## Certified Action of the City of Raleigh Planning Commission

**Case File / Name:** S-24-11 / Chestnut Hills Lot 21 & 22

### S-24-11 Chestnut Hills Lot 21 & 22

### S-24-12 Chestnut Hills – Subdivision Layout

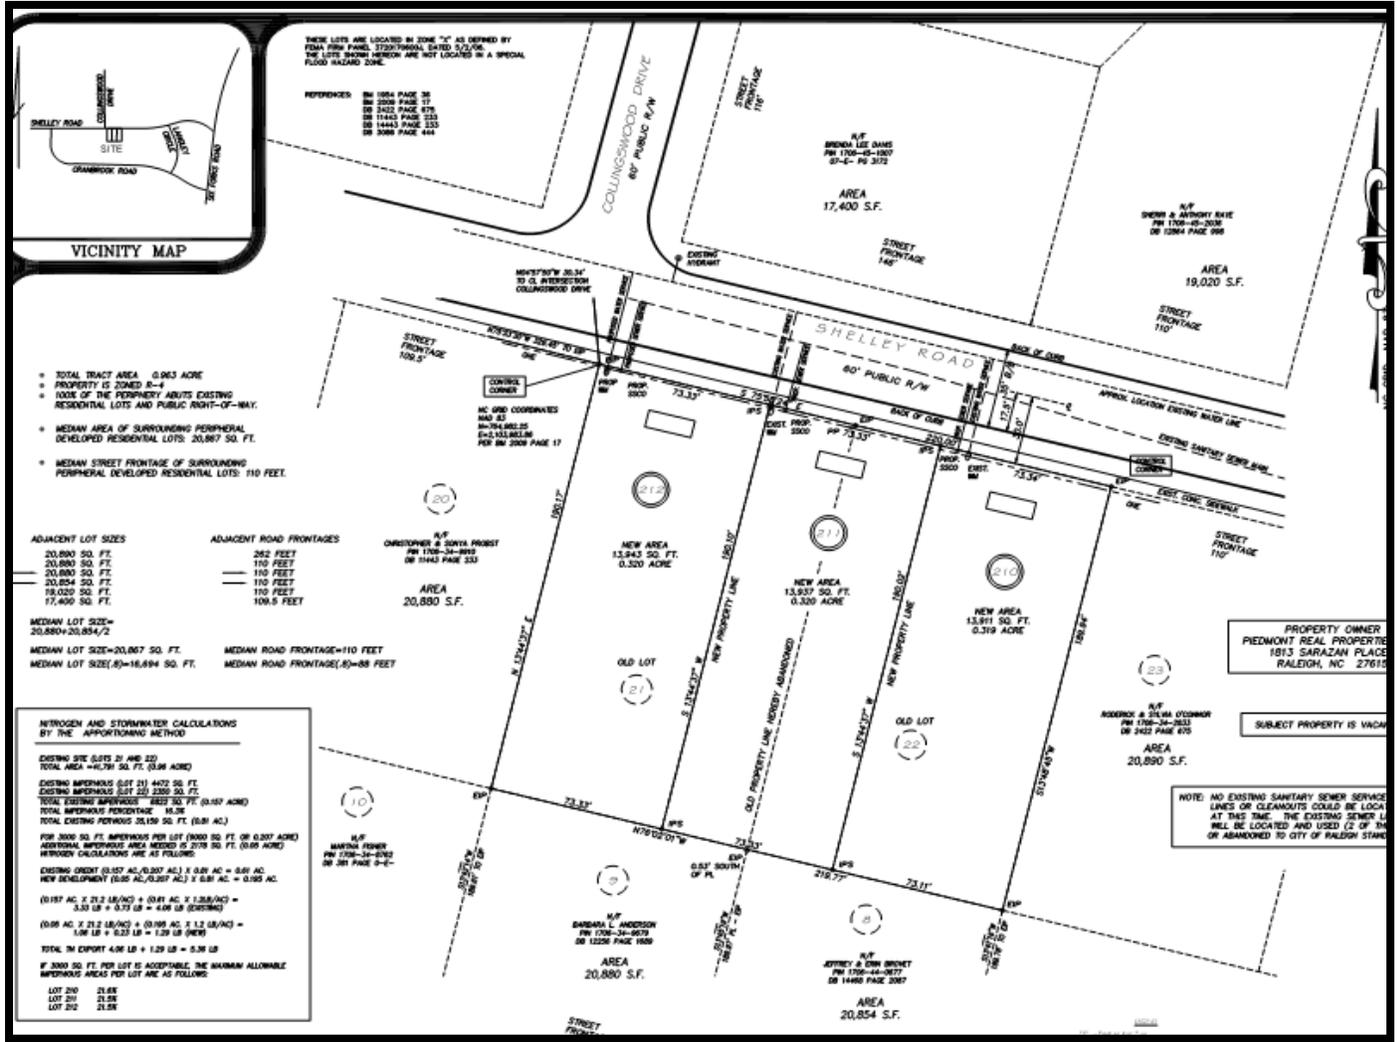
New lot 212 is proposed to be .320 acres (13,943 square feet) with a road frontage of 73 linear feet along Shelley Road. New lot 211 is proposed to be .320 acres (13,943 square feet) with a road frontage of 73 linear feet along Shelley Road. New Lot 210 is proposed to be .319 acres (13,911 square feet) with a road frontage of 73 linear feet along Shelley Road.

Proposed lot size lot #212	.320 acres (68% of median)
Proposed lot size lot #211	.320 acres (68% of median)
Proposed lot size lot #210	.319 acres (67% of median)

Proposed lot size lot #212	73' (66% of median)
Proposed lot size lot #211	73' (66% of median)
Proposed lot size lot #210	73' (66% of median)

**FINDINGS:** The Planning Commission finds that this request, with the following conditions of approval below being met, complies with the infill lot layout standards of 10-3032(d). The Planning Commission also finds that this plan conforms to Chapter 2, Part 10, Sections 10-2017, Chapter 3, Part 10, Sections 10-3001-3059. This approval is based on a preliminary plan dated 11/8/11, owned by Piedmont Real Properties, LLC, submitted by Griffin Land Surveying, Inc.

- (1) That the Planning Commission finds that this infill subdivision meets the lot layout standards of Section 10-3032(d);

- (3) That the recorded plat contains the following note: "A restrictive covenant for lots 210, 211, 212 has been recorded for impervious surface area, house size and building height;"

- (4) That a restrictive covenant has been recorded for lots 210, 211, 212 establishing a maximum floor area gross as defined in City Code Section 10-2002 of no more than 4,000 square feet, excluding finished floor attic and basement area, and a maximum building height not to exceed 36-feet from the average natural ground elevation [as per City Code Section 10-2076(b)]. That the City Attorney approves the restrictive covenant prior to its recordation and that the approved restrictive covenant shall be recorded with the county register of deeds office where the property is located. That the recorded copy of this restrictive covenant be provided to the Planning Department within 14 days of authorization of lot recording. If a recorded copy of this document is not provided to the Planning Department within the 14 day period, further plat recordings and building permits authorization may be withheld;

- (5) The entire site has an allowed maximum impervious surface, as defined in section 10-9002, of 10,050 square feet. This impervious surface area shall be allocated to each of the three lots in the restrictive covenant required in condition of approval number (4) above;
- (6) That documentation be submitted to the Stormwater Engineer in the Public Works Department that shows the maximum impervious surface coverage of the development on a per lot basis;
- (7) That a recombination of the two existing lots is recorded in conjunction with the lot recordation;
- (8) That the nitrogen offset payment must be made to a qualifying mitigation bank;
